**30-045-20733 G H CALLOW #006**

DJR OPERATING, LLC

**Plug and Abandonment Procedure**  
**for**  
**DJR Operating, LLC**  
**G. H. Callow 6**  
**API # 30-045-20733**  
**SW/NE, Unit G, Sec. 28, T29N, R13W**  
**San Juan County, NM**

**DJR Operating, LLC**  
**Proposed Wellbore Diagram**

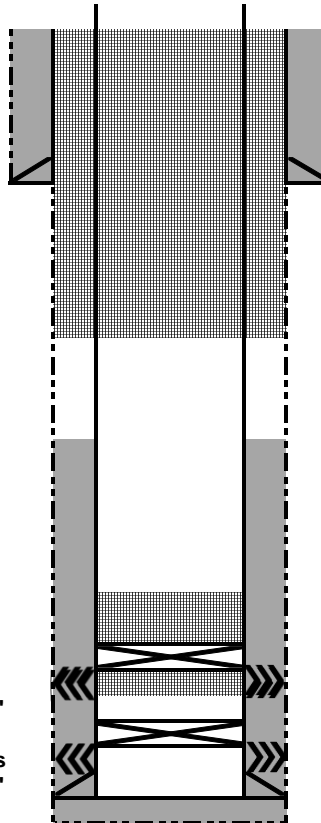
- Notify NMOCD 24 Hours prior to commencing activities
- In Addition to the BLM approved plugs
- CBL Required
- Add a plug 1060'-1160' inside/outside. OCD Fruitland pick @ 1110'.

- Please ensure that the top of the Fruitland, as well as the entire Ojo Alamo aquifer, identified in this report, are isolated by proper placement of cement plugs. This will protect the freshwater sands in this well bore.
